D2 Case No: A-21-1244827 Parcel ID(s): 18-249-01-124

Project Name: 3134 Smokestone Court

REQUEST: Variance from Chapter 27- 5.4.7.(D) – Walls, fences, and retaining walls of the DeKalb County Zoning Ordinance to increase of the maximum height for a proposed retaining wall from 4 feet to 8 feet.

Staff Recommendation: **“Approval with condition” based on the submitted site plan, received June 24, 2021, to increase the maximum height for a proposed retaining wall from 4 feet to 7 feet subject to the following condition:**

PLAN & ELEVATION VIEW SHEET

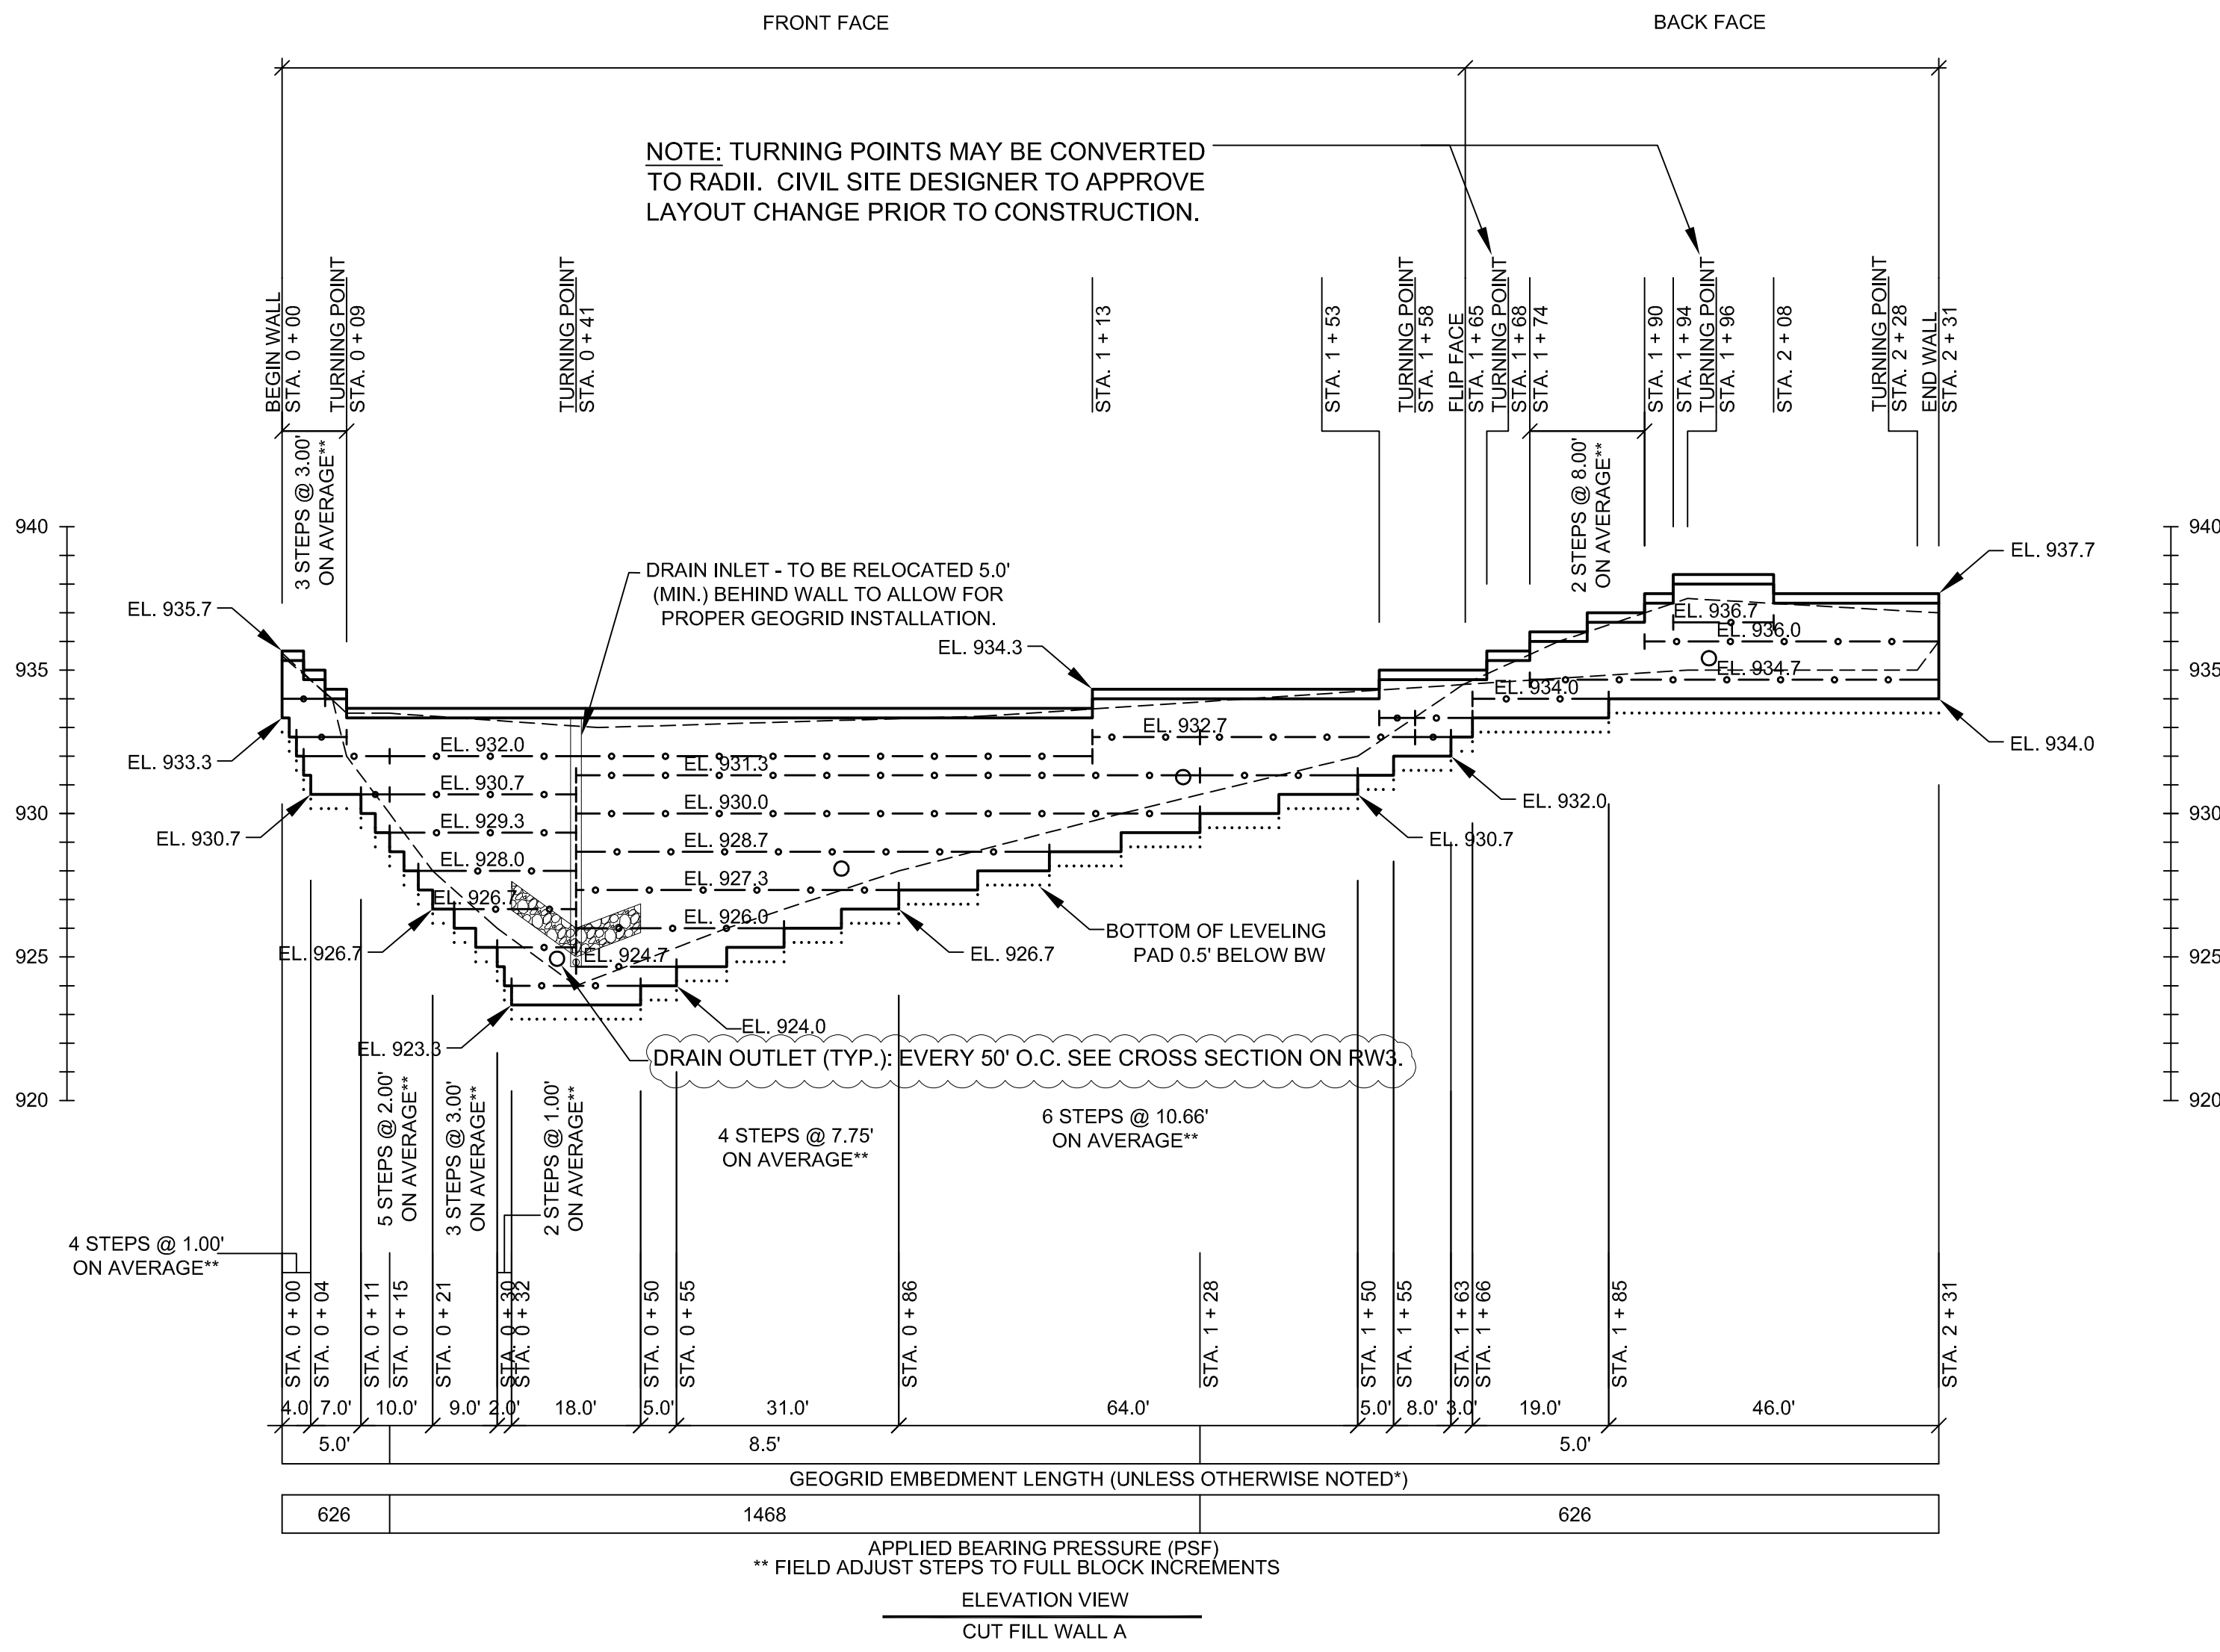
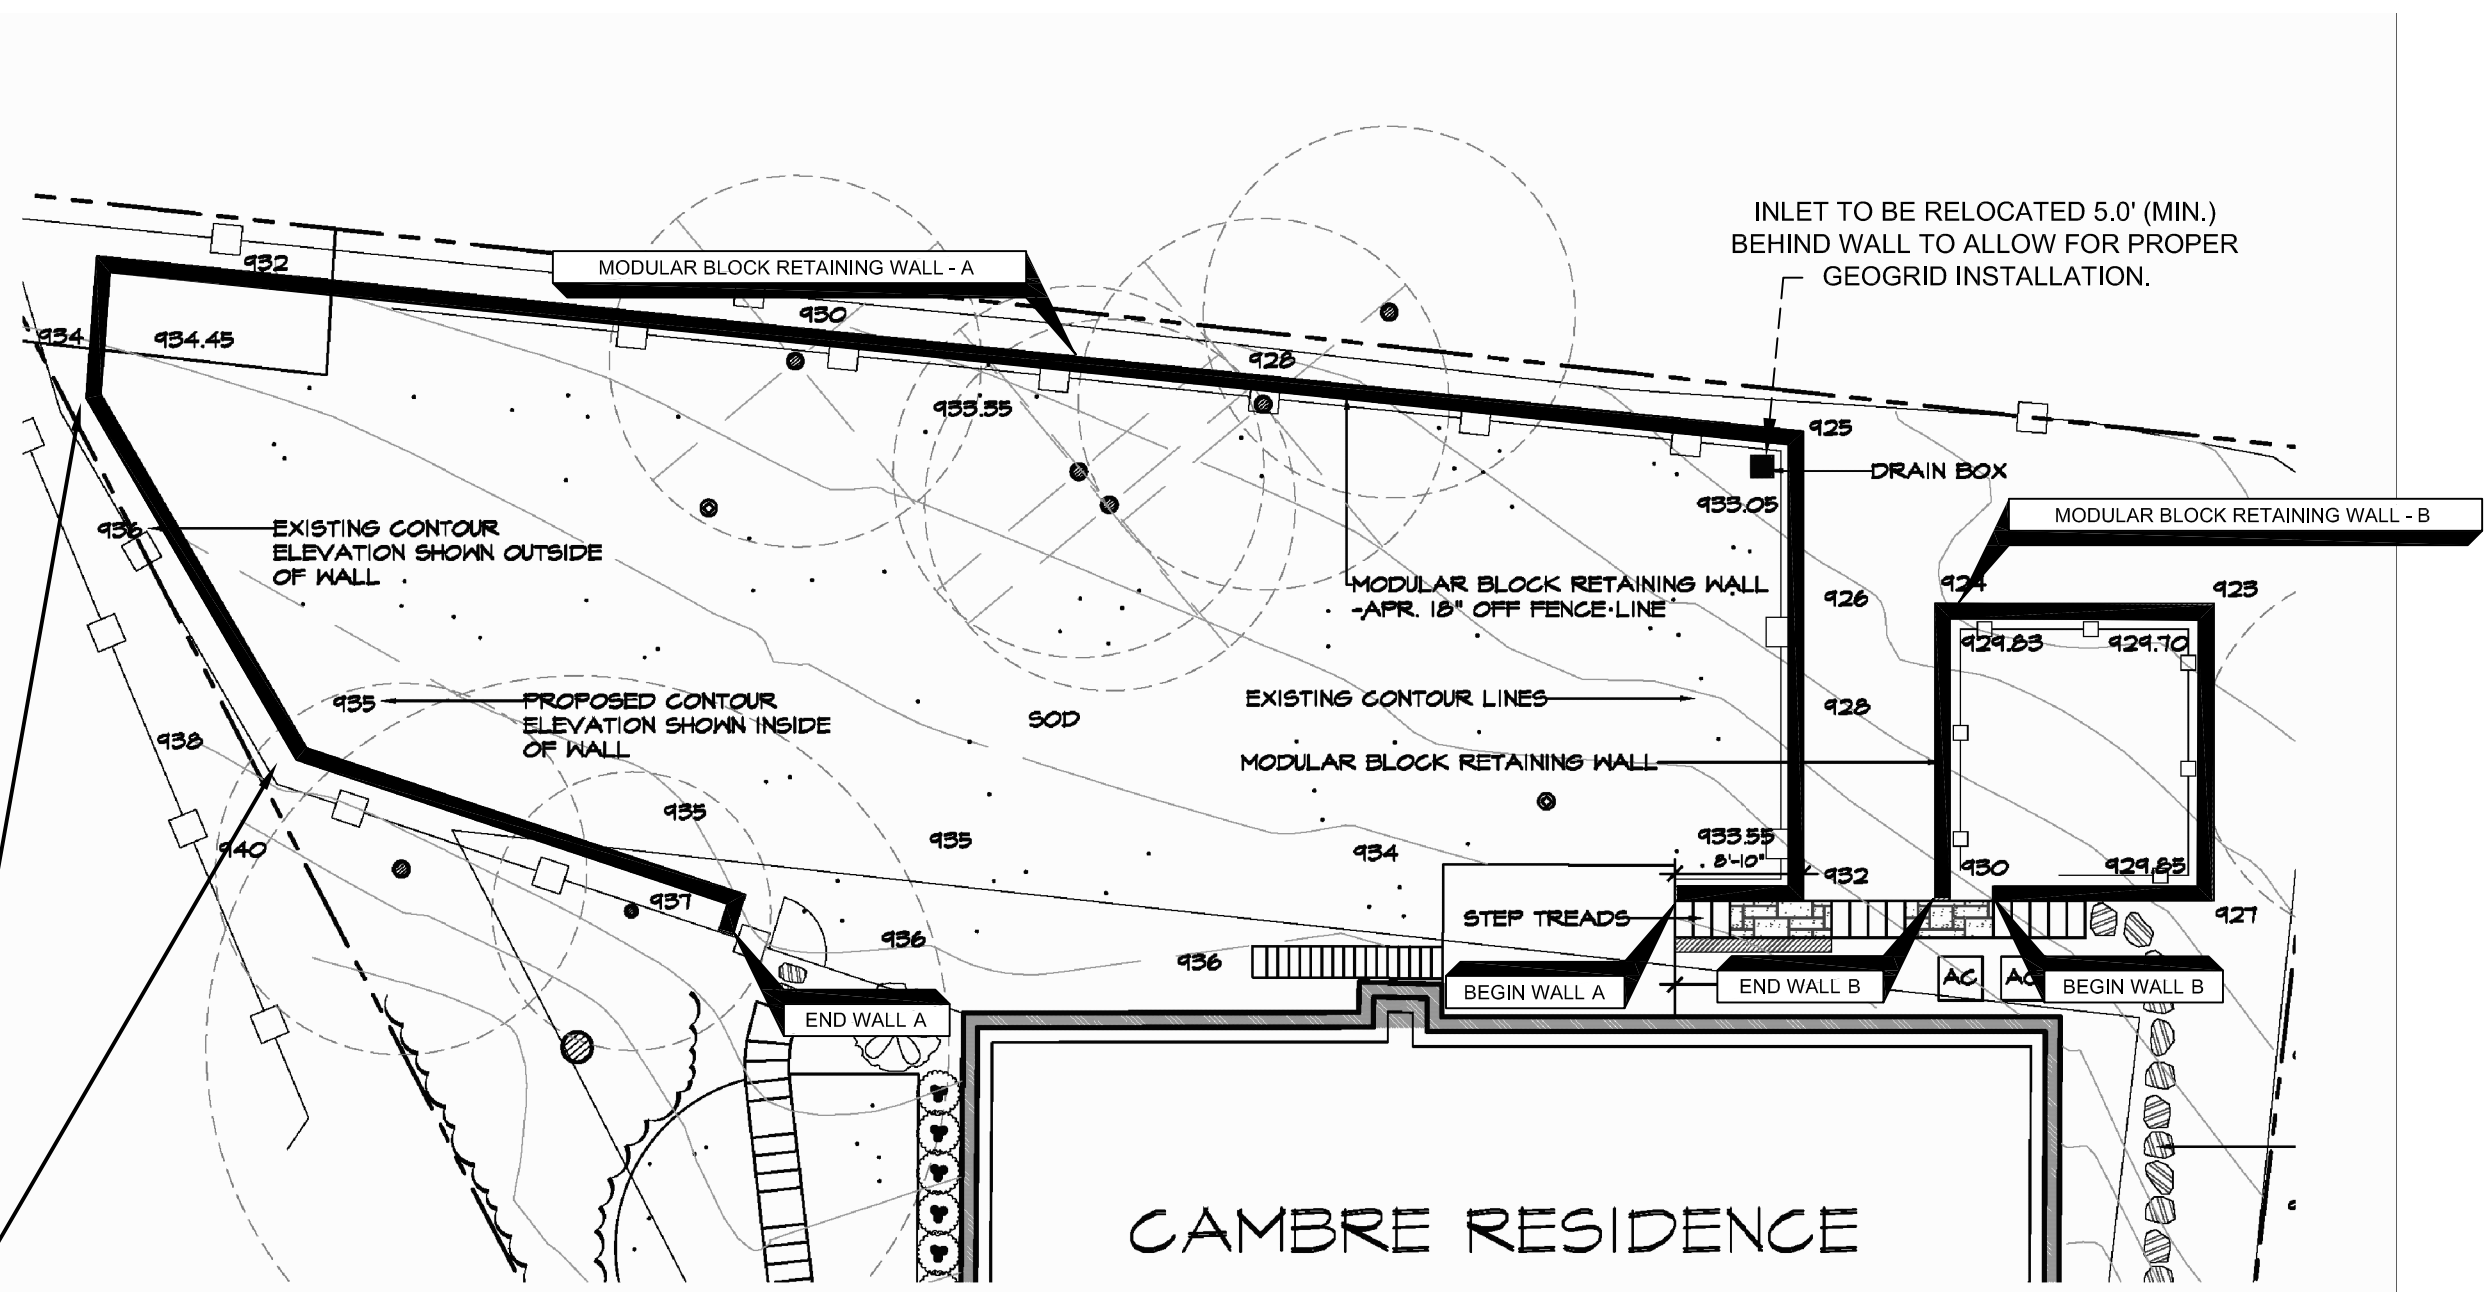
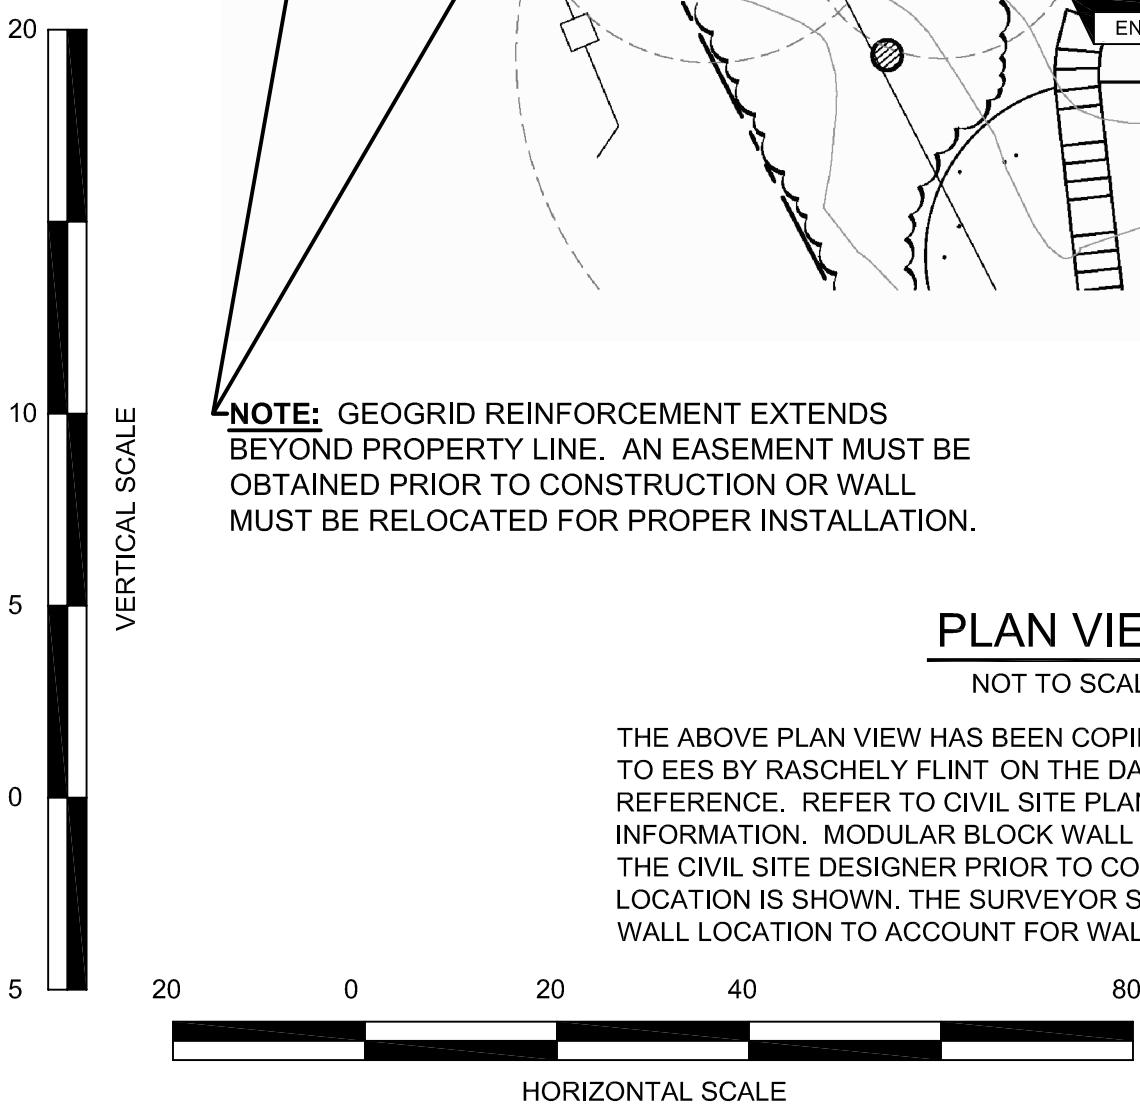
- Engineer has revised the wall design to address water quality control by adding 4" outlets every 50' along the wall as opposed to a concentrated single discharge point with fewer outlets.
- Proposed Additional Landscaping -canopy will also control and improve rain water drainage and distribution.
- See revised engineers plans.

NOTE: GEOGRID REINFORCEMENT EXTENDS BEYOND PROPERTY LINE. AN EASEMENT MUST BE OBTAINED PRIOR TO CONSTRUCTION OR WALL MUST BE RELOCATED FOR PROPER INSTALLATION.
